31/06-05O 10220 Carroll Place  
Kensington Historic District

RE: Patio/Hardscape Plan, 10220 Carroll Place, Kensington Historic District, Lot 29, Block 8, being a resubdivision of Lots 1 & 2, Block 8, Kensington Park

Re: Historic Area Work Permit # 396694  
10220 Carroll Place, Kensington, MD  
Primary 1 Resource within the *Kensington Master Plan Historic District*

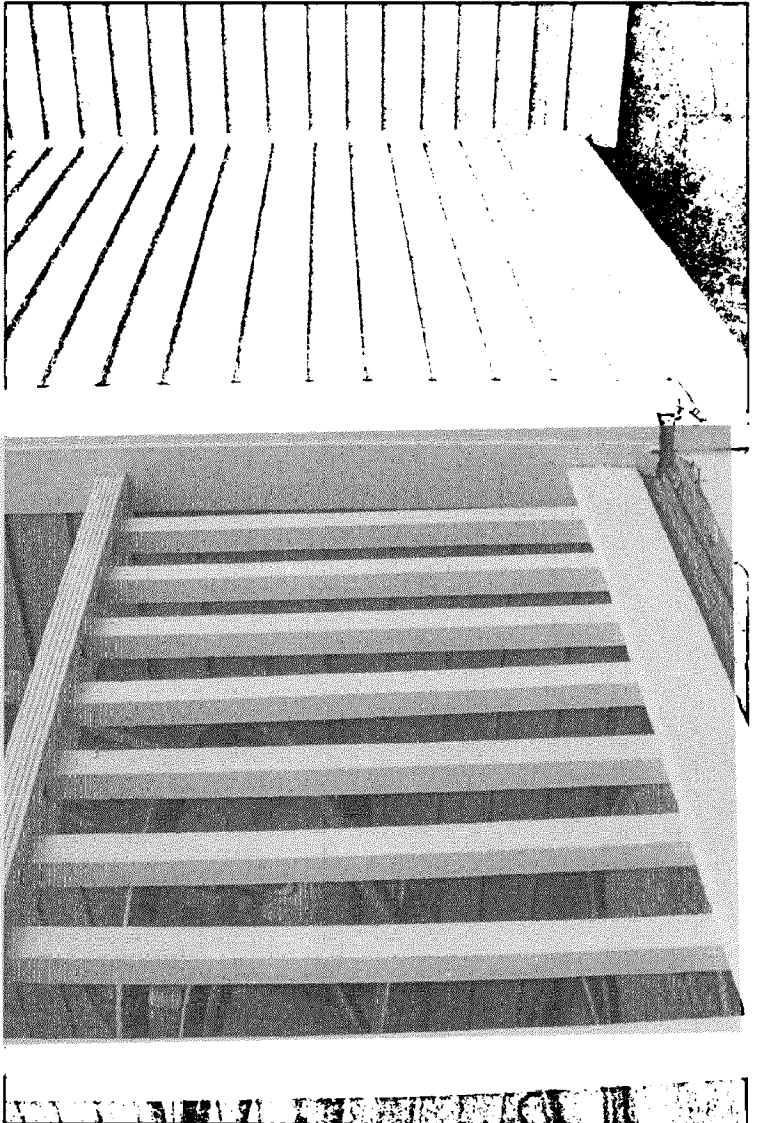
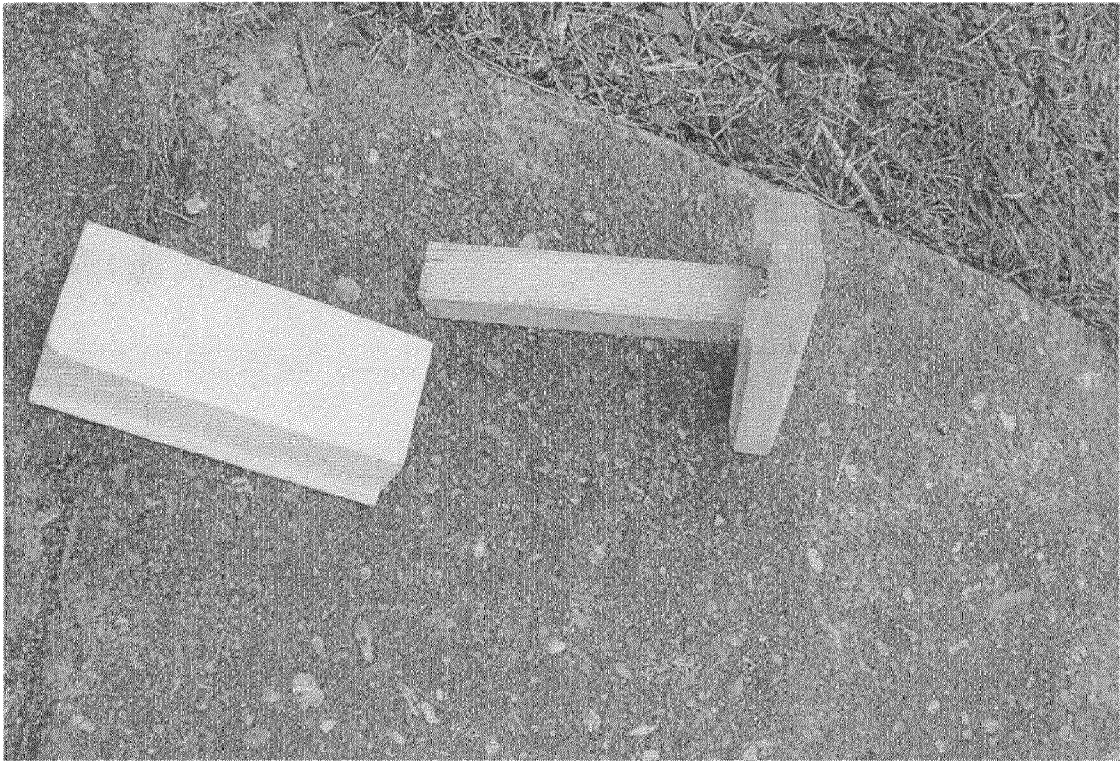
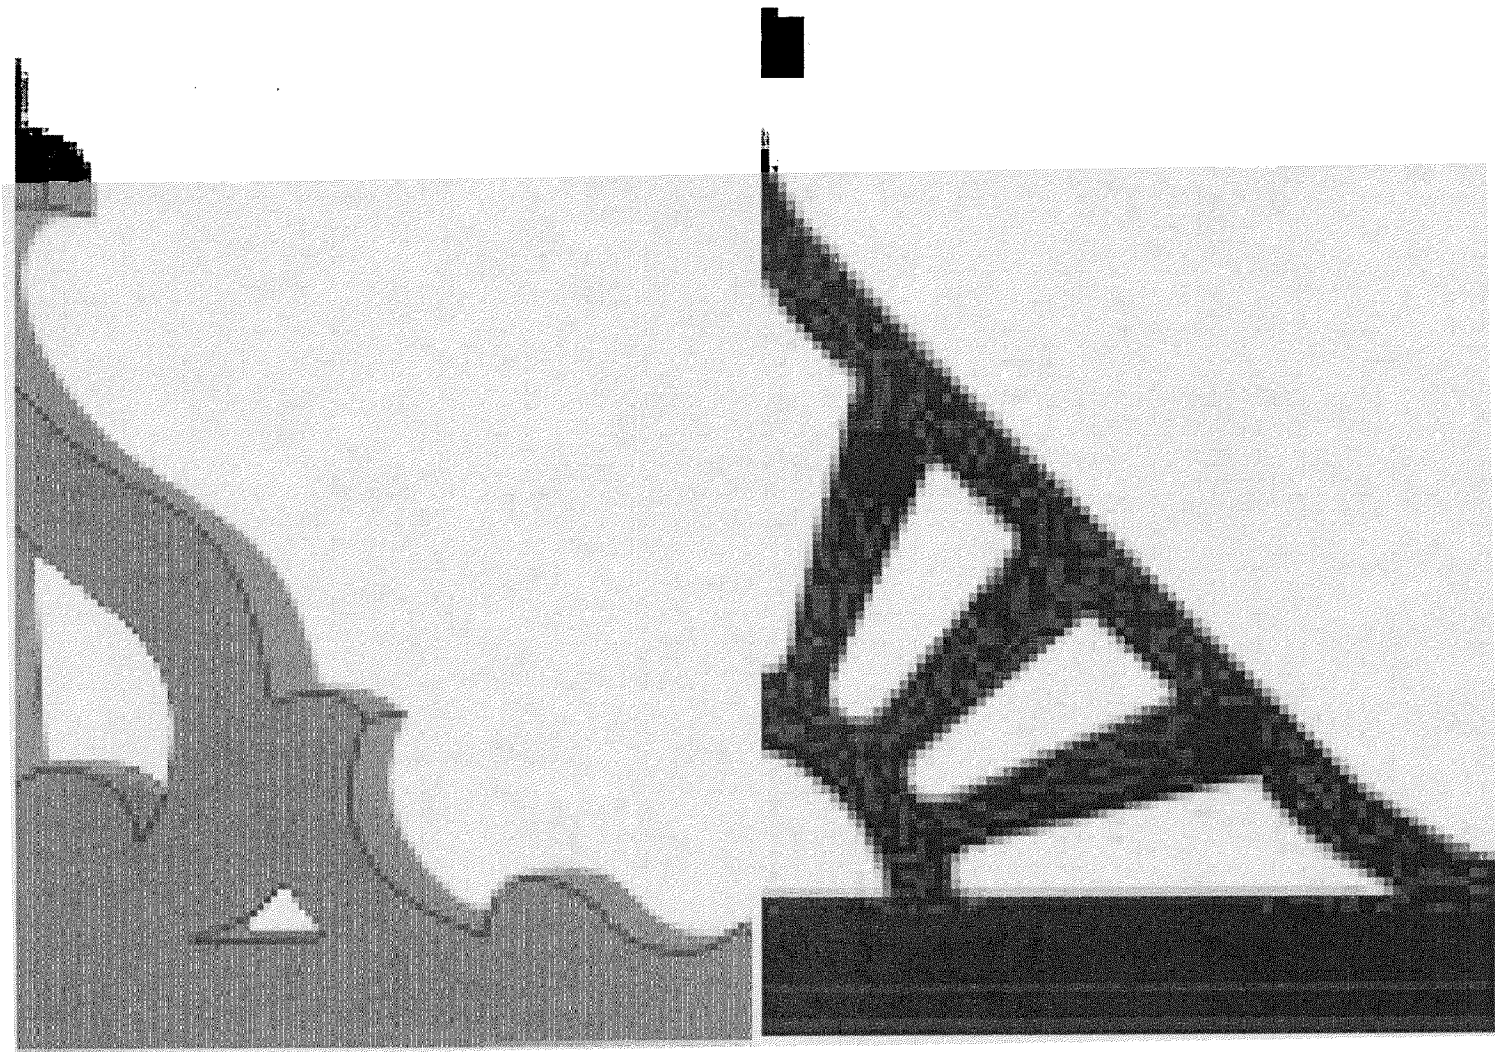
Attached are some bracket profiles. We are leaning toward the "sun-ray" designs. These come in a variety of wood species, typically 12-14 inches in length, 3/4 inches in width, with a 1-1/4" width frame.

Also attached are some sample rail kit pieces from the local lumberyard. While these are fairly plain, they are douglas fir, primed. It seems that a huge percentage of the historic porches in town have had these kits installed over the years, or have had parts of these kits used in repairs. I've attached images of a neighbor's porch. The house is a relatively untouched example of a Kensington house, but I don't know if their porch parts are original.

Can you let us know if these are acceptable (subject to MHT approval of the changes as illustrated on an Amendment form.)?

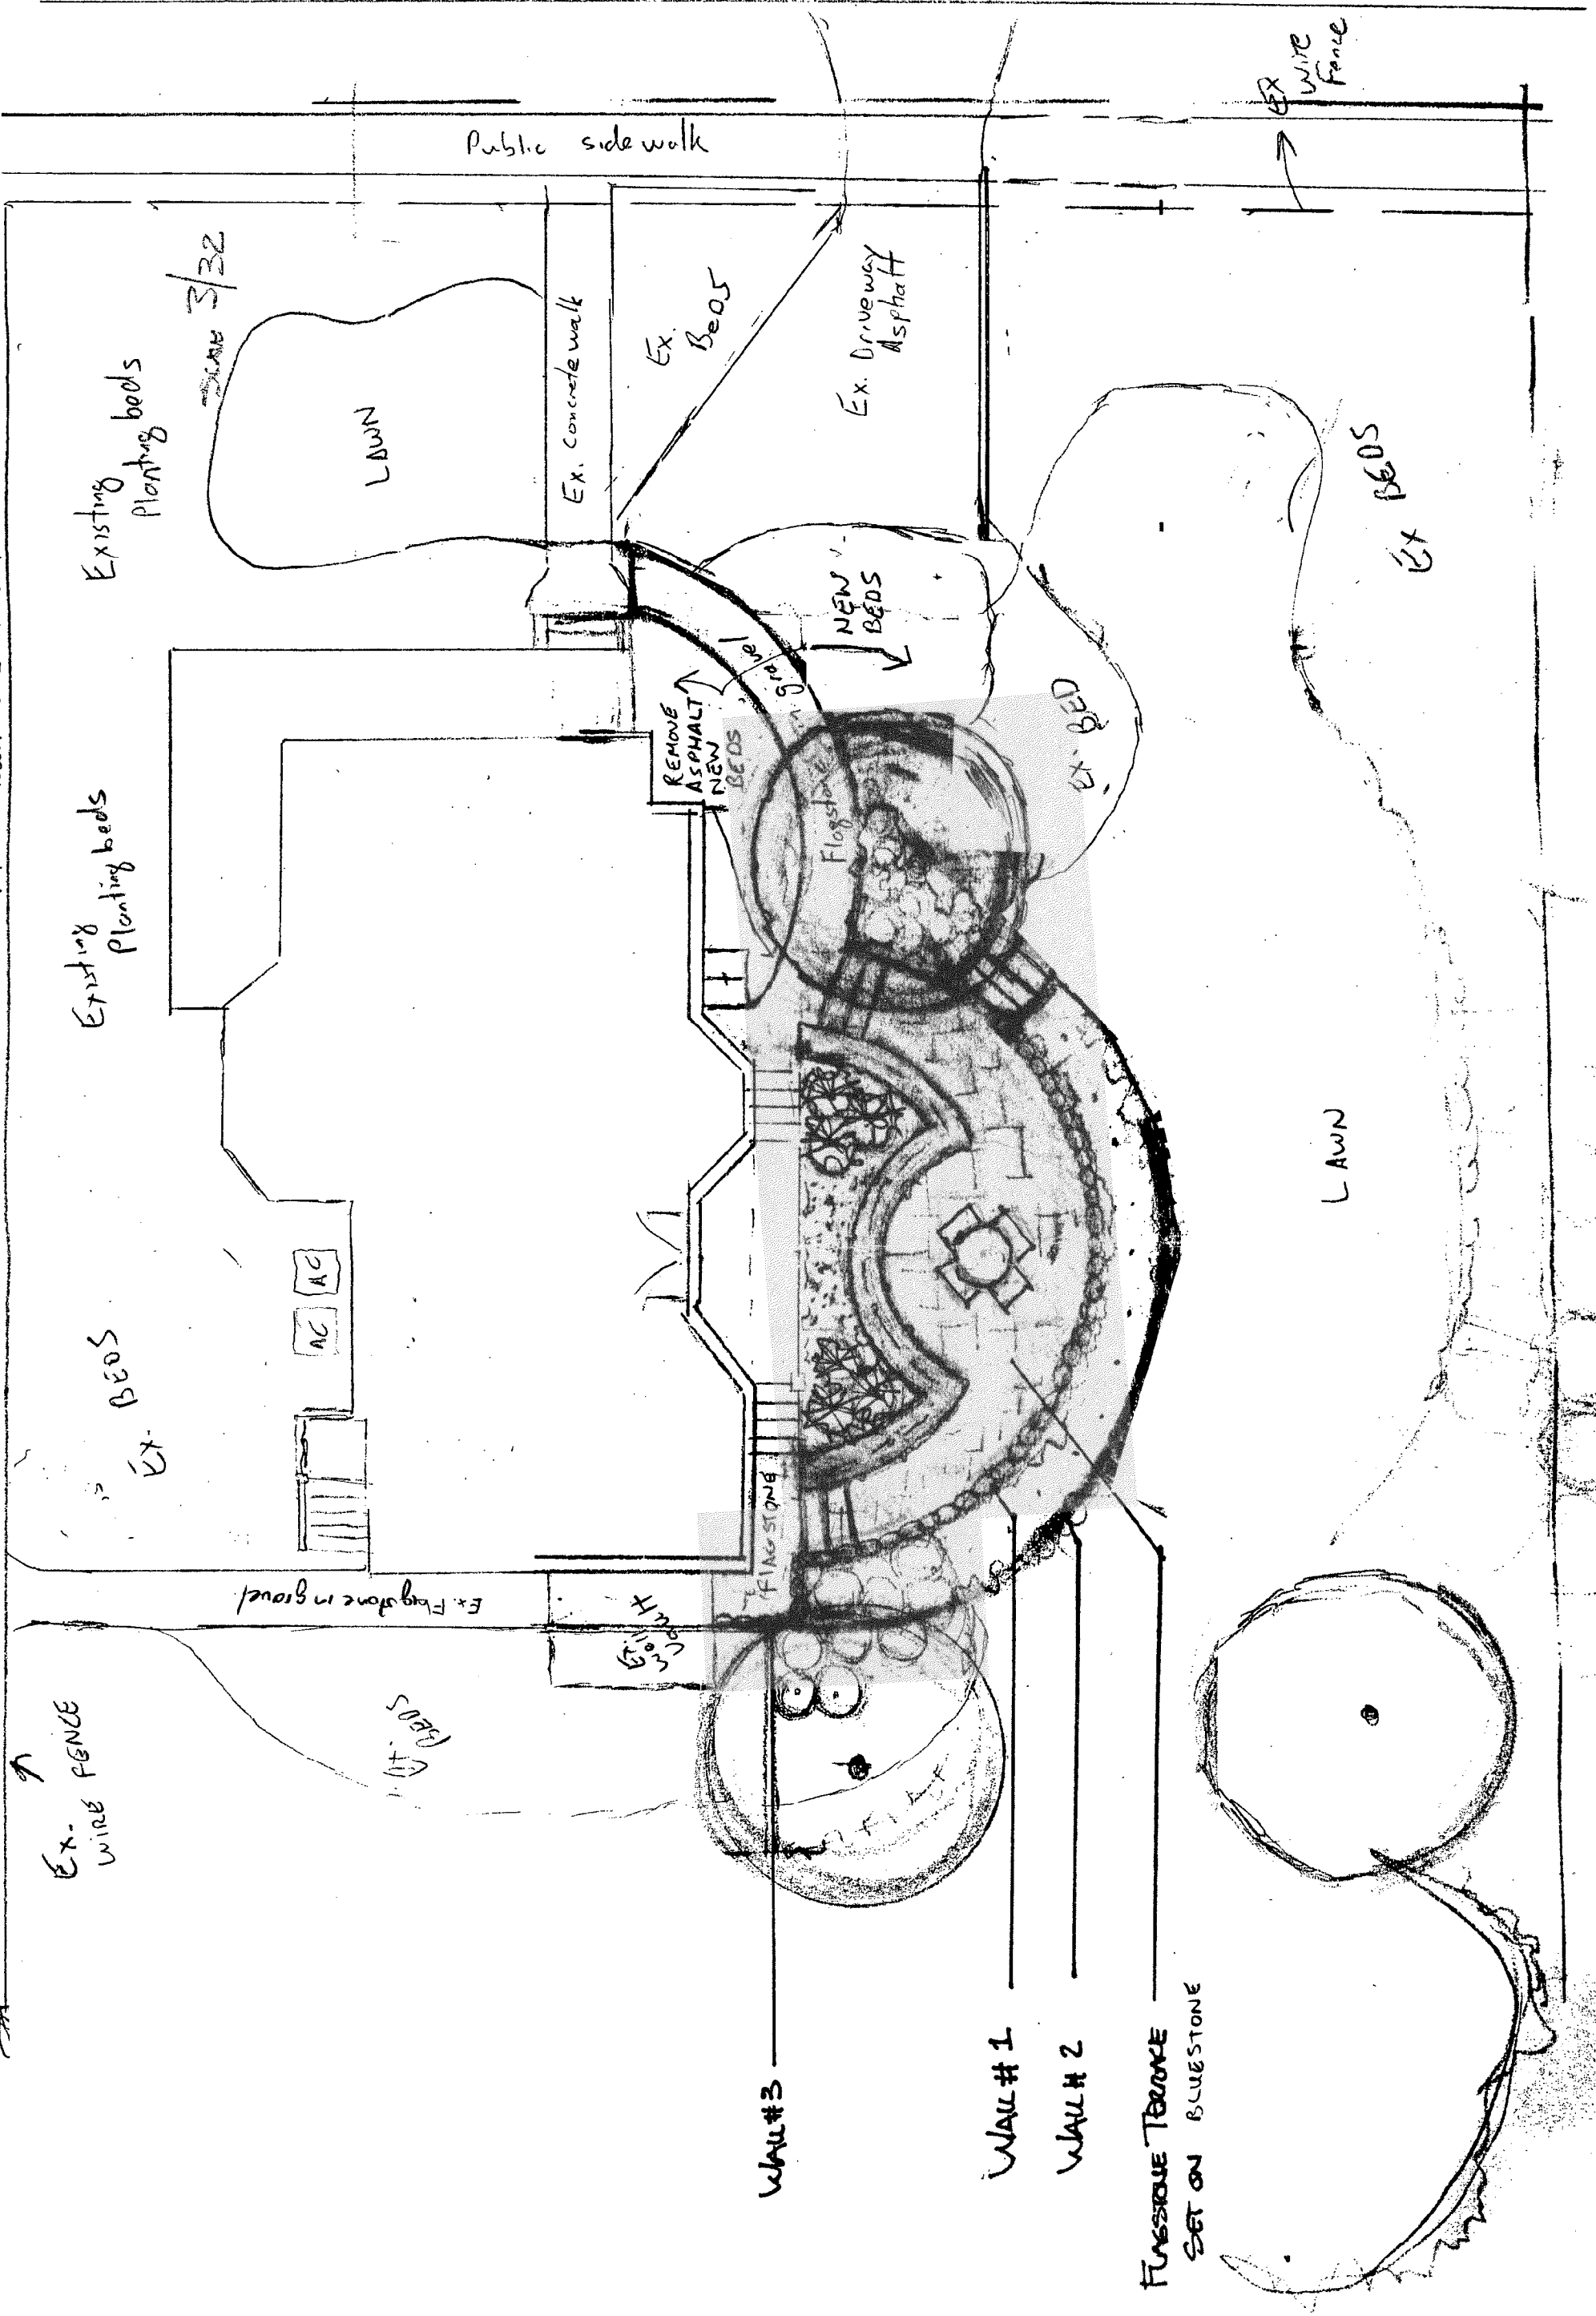
We propose revising our original patio/hardscape plan as presented in our approved HAWP as follows:

**Patio and access to lower yard:** The two small patios and massive circular staircase in the original plan will be replaced in the plan by one patio located below the new wooden deck/stairs outside the French doors. The new patio will be approximately 17 feet in diameter. The patio will be flagstone set on crushed bluestone. The patio's grade will be approximately 3 feet below the grade of the house and accessed by 2-3 steps dropping down from the flagstone walkways next to the house. Another series of 2-3 steps will drop from the patio to the side yard.

**Screening:** The patio's impact on the view from Carroll Place and Baltimore Street will be minimized by the use of new plantings and re-use of existing plantings such as sweetshrub/boxwoods/spirea. New plantings may include flowering trees such as ornamental cherry, eastern dogwood, or possibly a large species from the Maryland native tree list, if growing conditions allow. The wooden screens proposed in the original plan will not be installed.

**Grade Changes and Stone Walls:** The grade change between the upper yard near the house and the lower yard will be addressed by a series of 3 stacked stone walls, generally not more than 4 feet high. The height of the walls will depend upon the existing grade changes. Walls are specified as "Endless Mountain" stone, which is a brand of natural Pennsylvania field stone from Endless Mountain Stone Co.

**Paving:** Walkways will be flagstone set in gravel/bluestone. The existing driveway on Carroll Place will remain, but will be reduced greatly in size by removing the existing paving next to the house. With the exception of the indicated flagstone walk going from the front walkway to the new wooden deck stairs, areas with paving removed will be converted to planting beds.

**Please utilize this letter as formal approval for this revision.** Thank you for your assistance in this matter. If you have any questions, please do not hesitate to contact staff at 301-563-3400.

1
**WEST ELEVATION**  
 1/4"=1'-0"

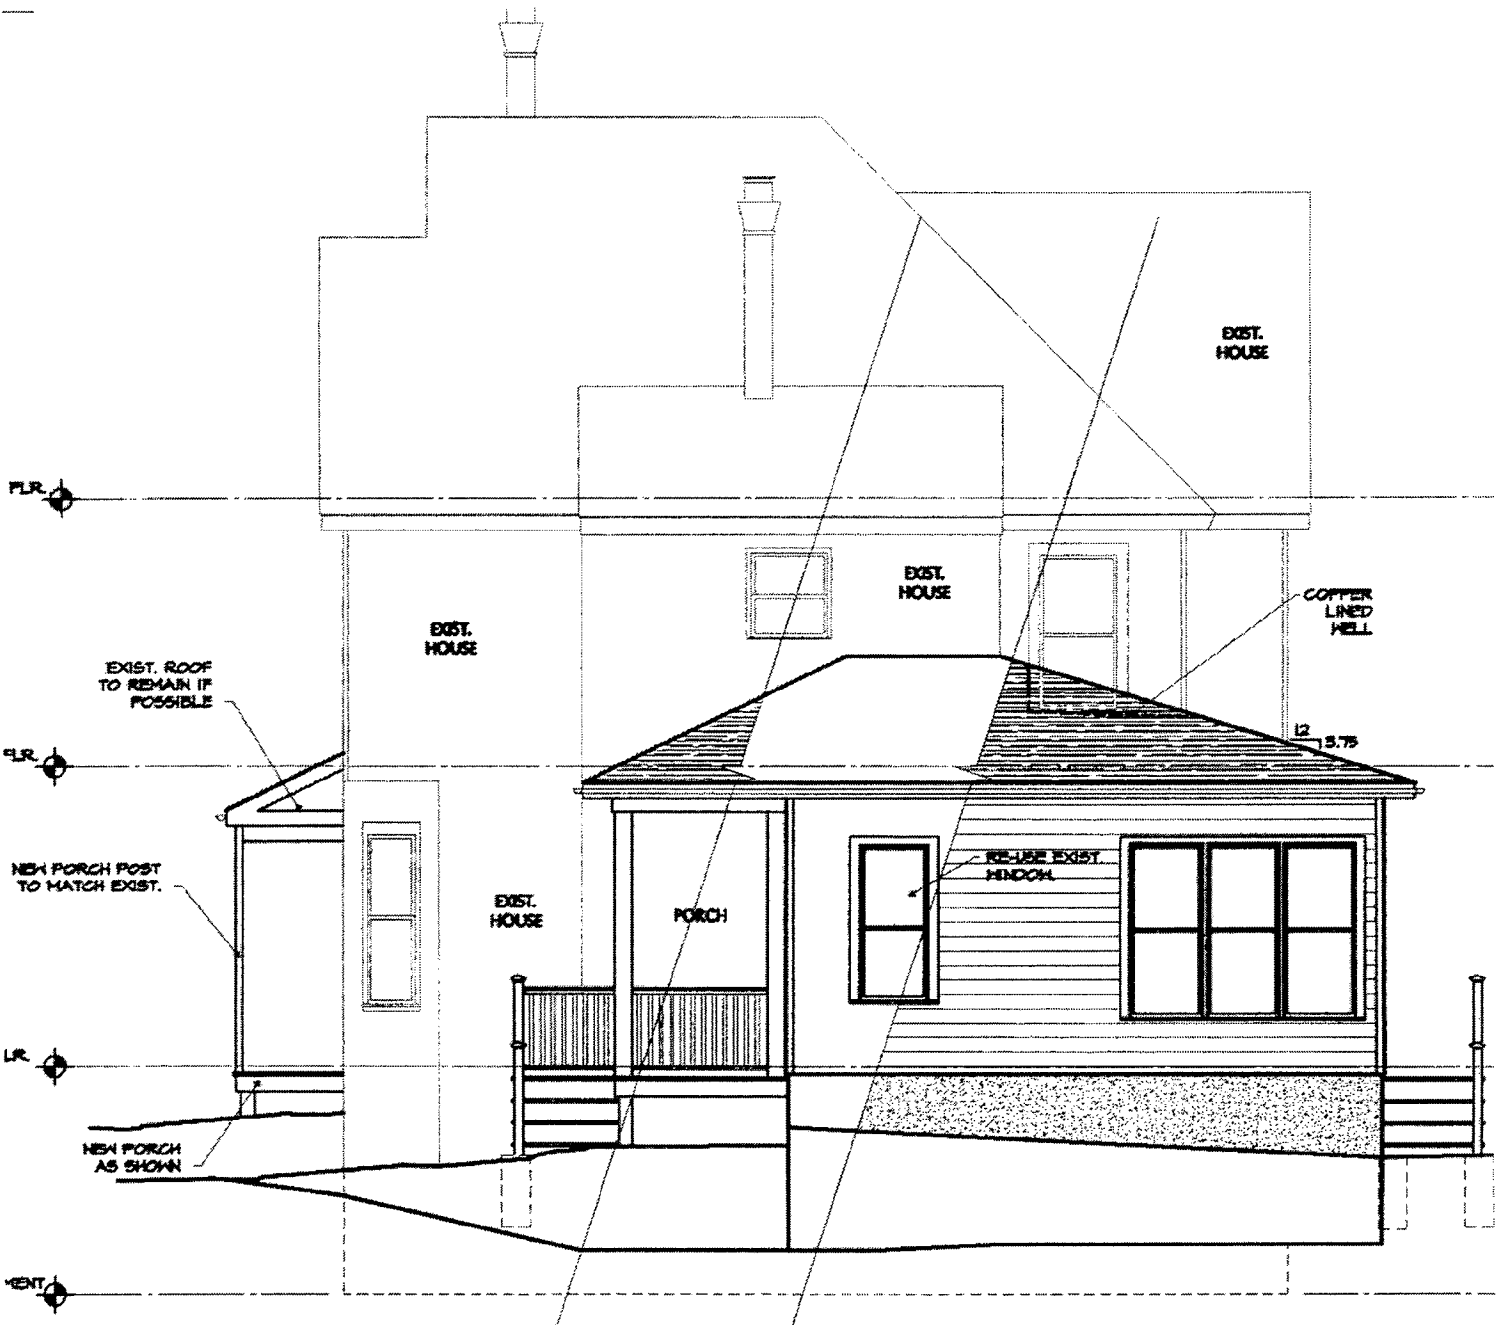
I may have already asked you this: we are re-configuring the first floor schematic. Instead of the powderroom in the middle of the house, it will go in the back where the mudroom was planned. This results in no changes to the exterior elevations.

I discussed with our builder, Paul Kuzma, re-using the smaller historic 1/1 window that we are taking out between the kitchen and the planned family room. It would go in the rear powderroom on the western elevation. He recommended that we install a storm window to help cut down the draft. Storm window would probably be aluminum triple track, similar to what is currently on the rest of the original house (installed by the previous owner.) This would change the western elevation by breaking up the somewhat long wall between the new rear porch and the three new 1/1 double hung windows on the family room addition.

Would that be ok? We can get you a revised elevation if necessary.

I think that's fine, but I will need a revised elevation in order to formally give approval.
